Clinton Power Station

Subject: Additional Information Supporting the License Amendment Request to Permit
Upated Power Operation at Clinton Power Station

Additional Information Supporting the License Amendment Request to Permit Upgraded Power Operation at Clinton Power Station

Figure 4.2-1 Simplified VC Diagram - A Train "Hi Rad"

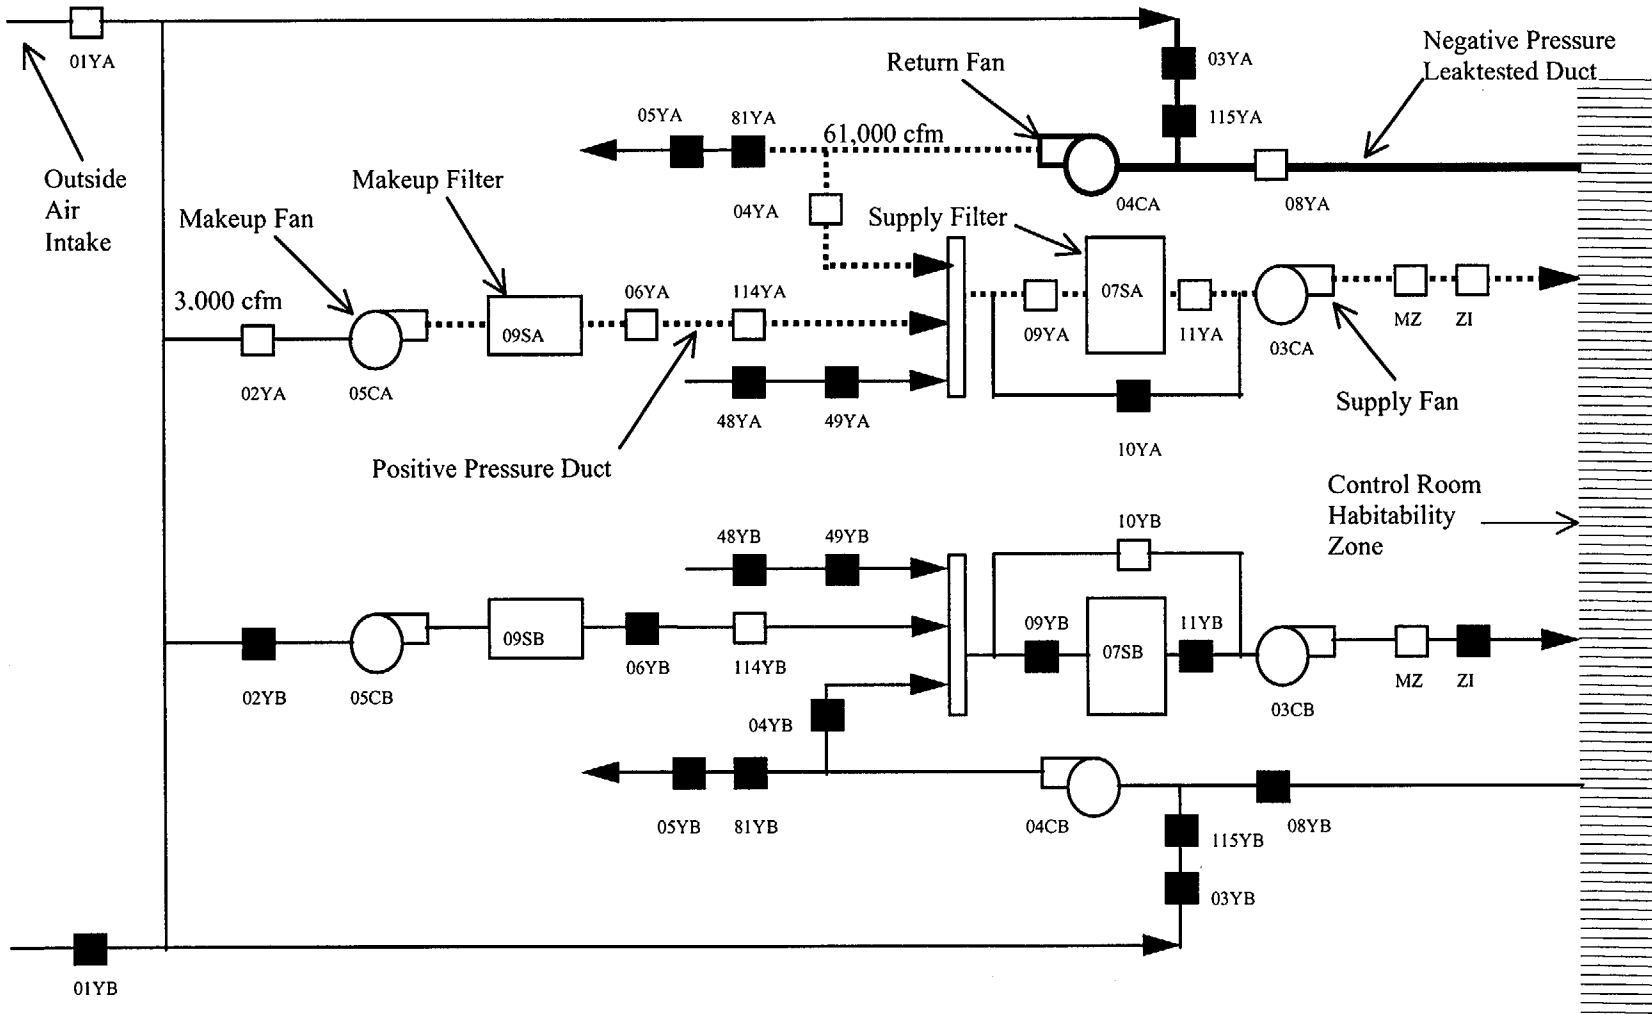
The staff has reviewed Amergen's response dated October 17, 2001 to its request for additional information. Question 4.2e requested: "Please provide a justification for control room unfiltered inleakage assumptions that have not been substantiated by appropriate integrated boundary leakage testing." Based on the information provided, the staff finds the Amergen response to be insufficient. Amergen is requested to supplement its response to RAI Question 4.2e with the requested justification of the CRS unfiltered inleakage assumption.

Several power reactors (representing over 20% of the U.S. plants, including those with filtered zone isolation and pressurization) have performed integrated testing of their control room inleakage, and in all but one case, the test results showed inleakage in excess of the facility's design basis. Based on this experience, concluding that the positive pressurization surveillance tests would result in no unfiltered inleakage (other than access doorways) during an accident condition is questionable. Given Amergen's projected post-EPU dose for the control room of 29 rem out of an allowable 30 rem, a increase in unfiltered inleakage could result in doses exceeding GDC-19.

The sources of contaminated air used in the dose assessment are based on the design of the CRVS, which utilizes zone isolation with filtered recirculation and zone pressurization. A simplified diagram of the system is shown in Figure 4.2-1. The system consists of two independent trains composed of a supply fan, a return fan, a makeup fan, a supply air filter package and a makeup air filter package. Each train is capable of

providing 100% of the required air flow, so only one train is normally operating. When the High Radiation (i.e., "Hi Rad") mode of operation is initiated by high radiation readings in the intake duct, the makeup fan in the operating train, which is normally not running, is automatically started. A nominal makeup flow of 3,000 cfm is passed through the makeup filter unit, which contains a 99% efficient charcoal filter for iodine removal. The return fan continues to operate at a nominal flow rate of 61,000 cfm from the control room. The return, or recirculation, flow is combined with the makeup flow and is passed through the supply filter before being supplied to the control room. The supply filter unit contains a 70% efficient charcoal filter for iodine removal.

A significant portion of the ductwork and equipment in the CRVS is located outside the control room habitability zone. Ductwork outside the control room is a potential pathway for inleakage of unfiltered and potentially contaminated outside air if the ductwork is at negative pressure relative to the outside atmosphere. The only portion of the system that is at negative pressure during the "Hi Rad" mode of operation is the ductwork upstream of the return fan. Technical Specifications (TS) assure that the actual inleakage into this ductwork is less than the value used in the dose assessment. Any leakage into this ductwork passes through the supply filter, so this is considered filtered inleakage. The design of the system is such that the remainder of the ductwork downstream of the charcoal filters is maintained at positive pressure, which precludes the infiltration of additional outside air into the CRVS.

This design was selected to preclude unidentified, unfiltered leakage of outside air into the control room envelope. The supply of 3,000 cfm of outside air is sufficient to maintain the pressure inside the control room at greater than 1/8-inch water gauge relative to all adjacent areas. Also, control room access is controlled through vestibules with two doors in series to preclude leakage into the control room during access or egress. The dose assessment conservatively assumes 10 cfm of unfiltered inleakage, which is in addition to the 650 cfm of filtered inleakage into the ductwork outside containment. The conclusion that the inleakage assumed in the Clinton Power Station (CPS) dose assessment is conservative is based on three considerations.
